Access Compliance Report Public Rights-of-Way (Pedestrian Signals)

Main Street: PERDIDO_ST Cross Street: BALL_RD Location: SE

ADA ID: SGRK210923172427 Signal Type: One Push Button-Non APS Overall Compliance: No Severity Scores: BTN 1: 35 BTN 2: N/A No BTN: N/A

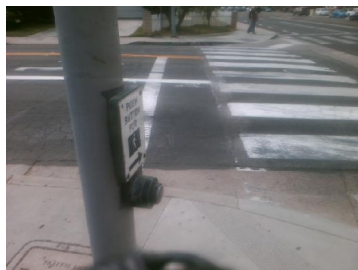
Surveyor Notes: N/A

Possible Solutions: Replace Signal Push Button With APS Button. Remove and Replace Clear Space.
